RETREAT AT TIMBERRIDGE FILING NO. 1

CONSTRUCTION DRAWINGS

Engineering Review
05/15/2020 10:27:32 AM
dsdrice
JeffRice@elpasoco.com
(719) 520-7877
EPC Planning & Community
Development Department

RABBIT TAIL PLACE
(50' R.O.W. - URBAN LOCAL)
DESIGN SPEED 25 MPH

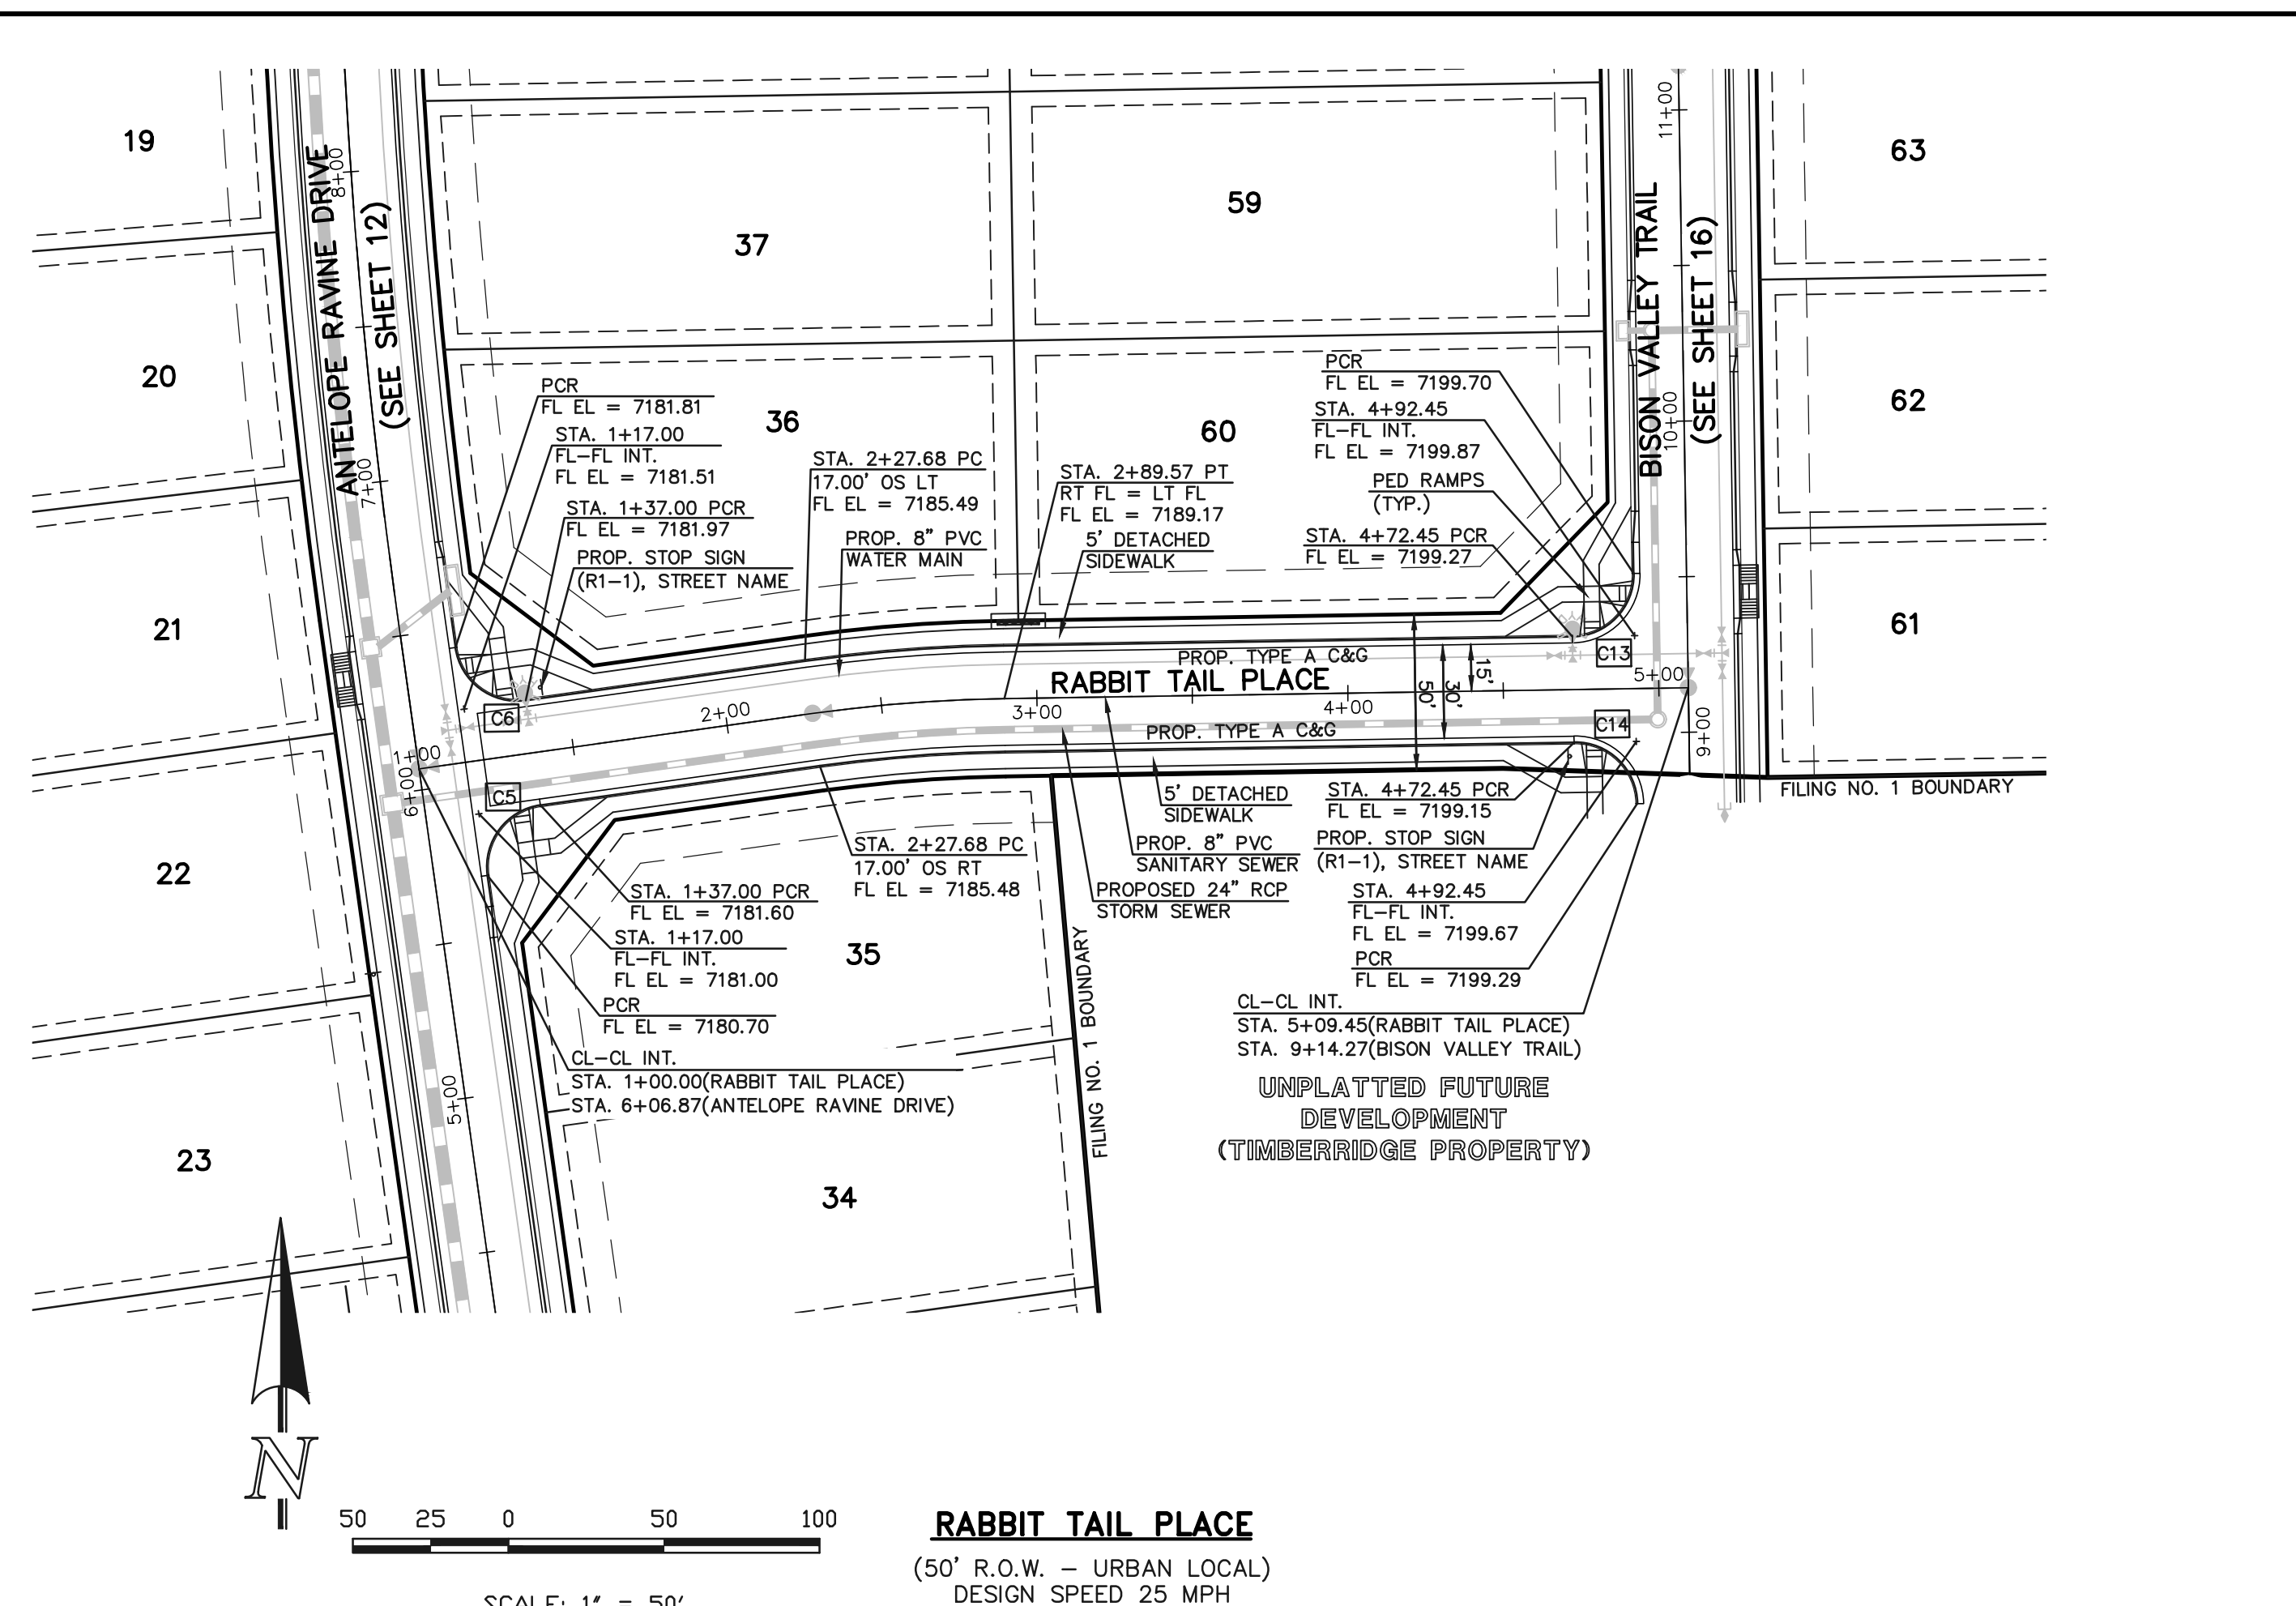
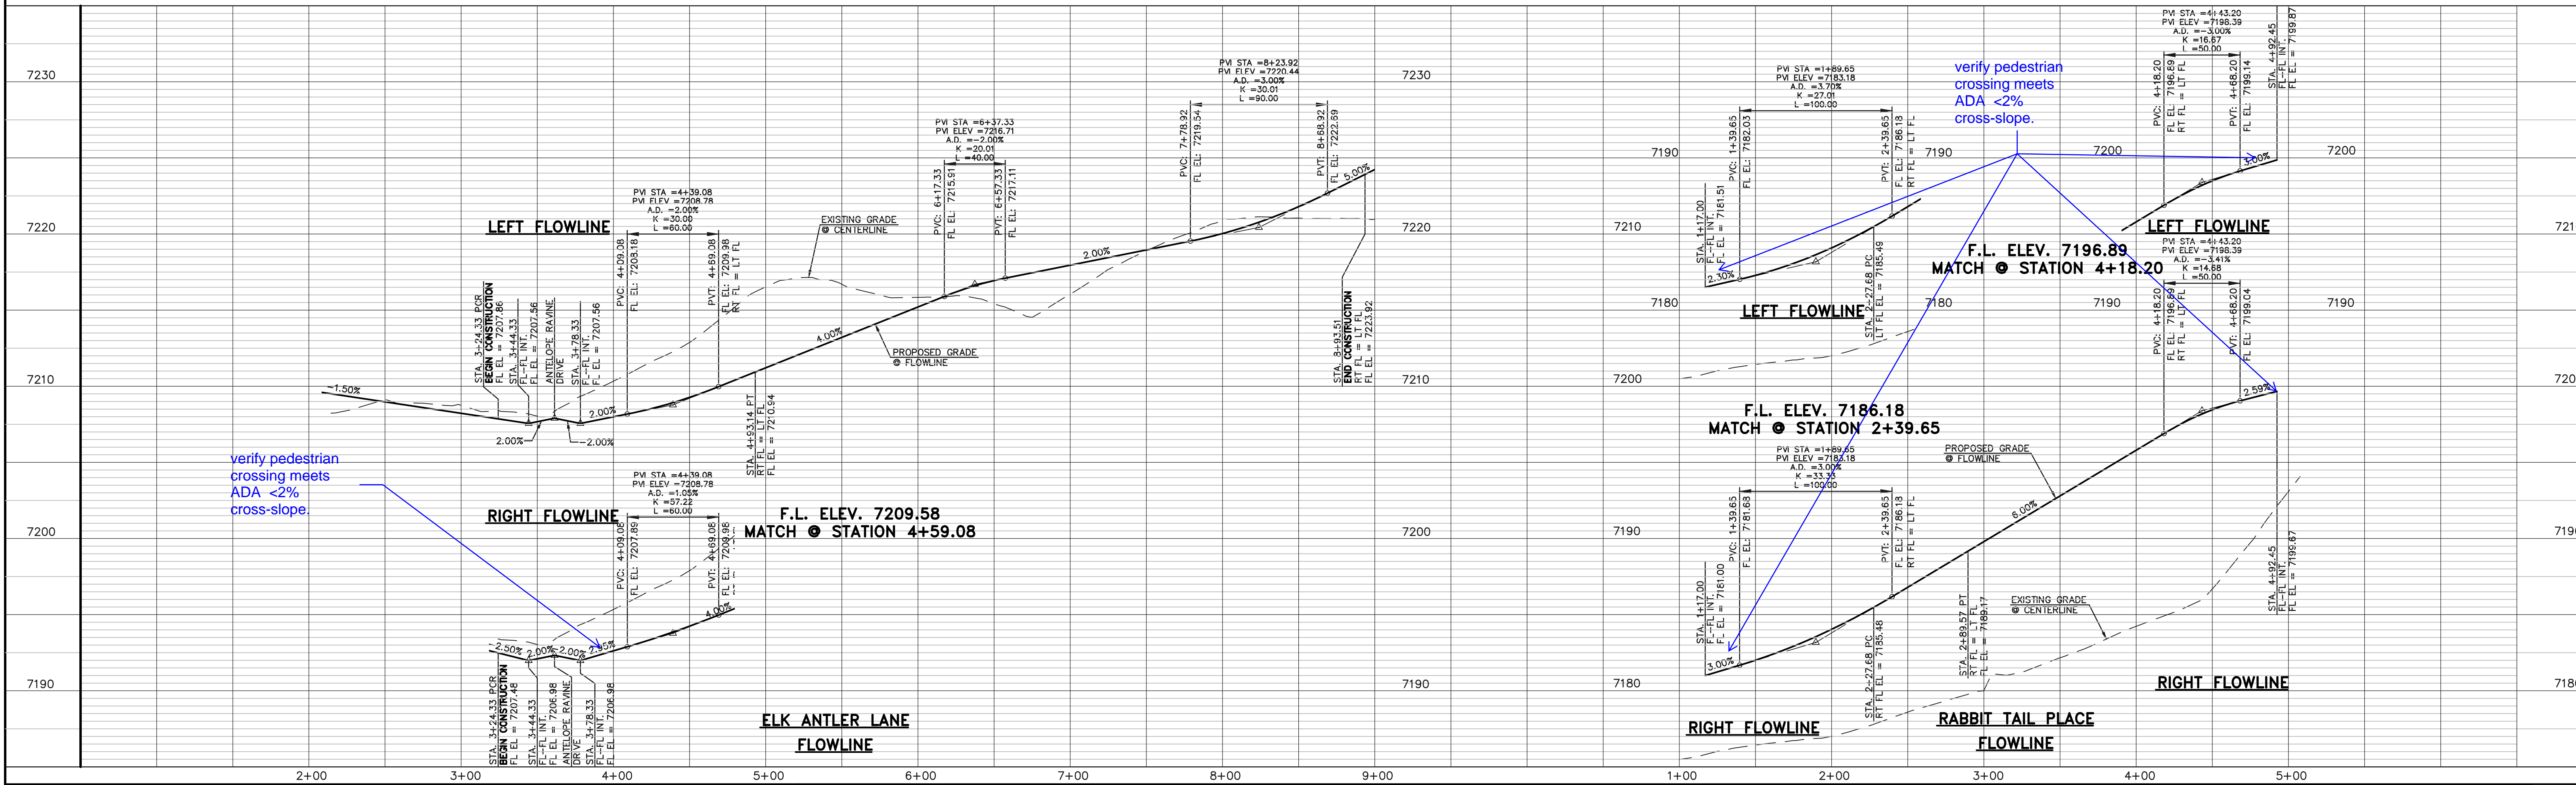
verify pedestrian crossing meets ADA <2% cross-slope.

verify pedestrian crossing meets ADA <2% cross-slope.

BISON VALLEY TRAIL
(50' R.O.W. - URBAN LOCAL)
DESIGN SPEED 25 MPH

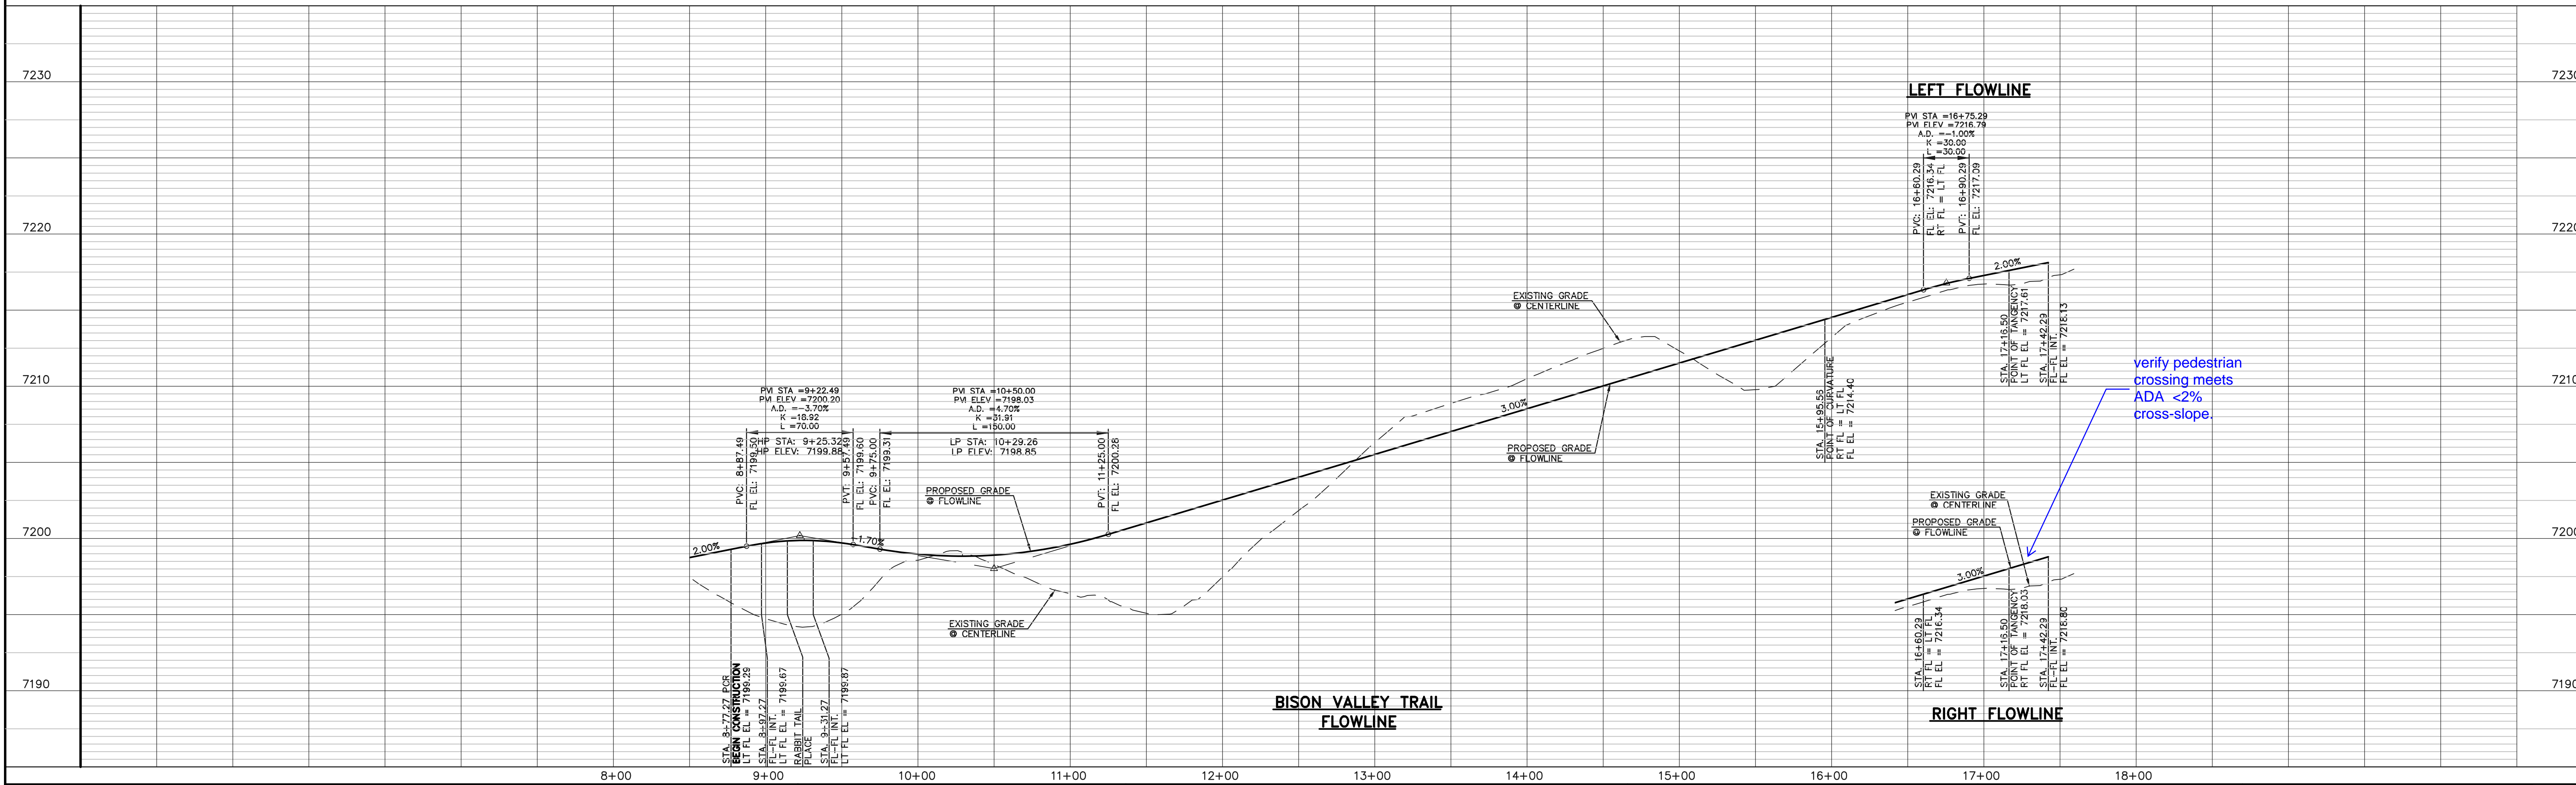
verify pedestrian crossing meets ADA <2% cross-slope.

RETRAIT AT TIMBERIDGE FILING NO. 1 CONSTRUCTION PLANS POCO ROAD CULVERT CROSSING			
DESIGNED BY	PRA	SCALE	DATE 04-05-19
DRAWN BY	PRA	(H) 1" = 30'	SHEET 26 OF 35
CHECKED BY		(V) 1" = 3'	JOB NO. 1185.00

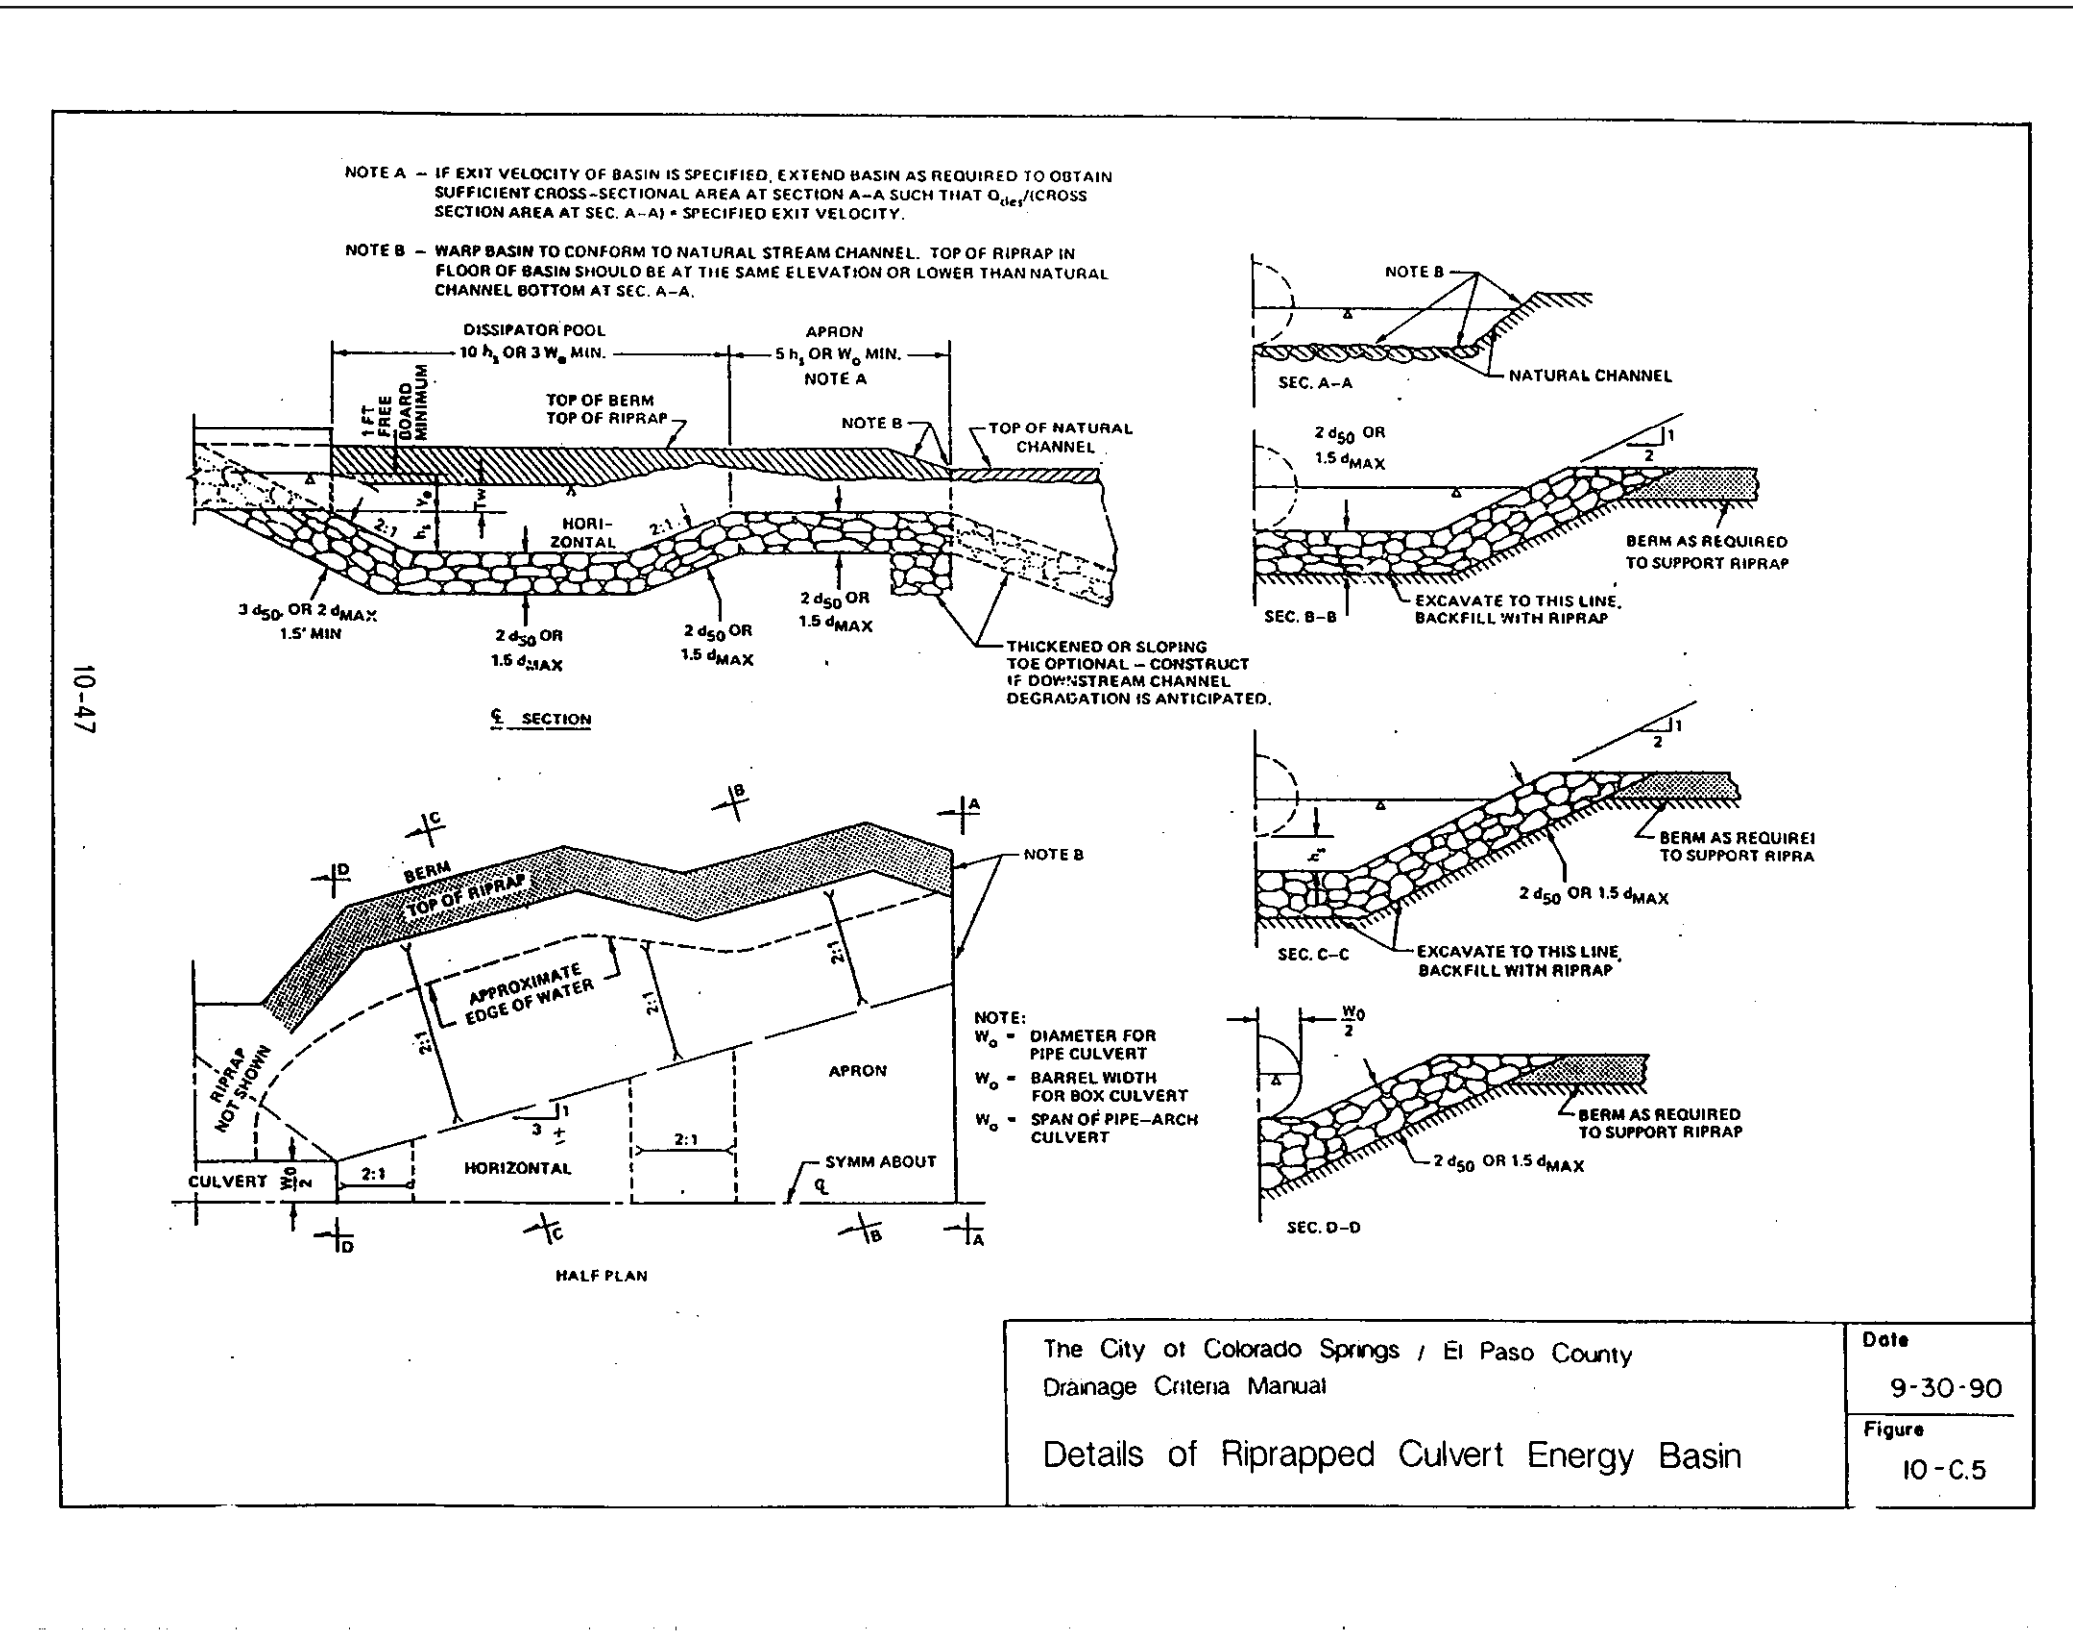
The invert should be lower to match existing grade here, or additional protection provided on the steeper slope downstream.
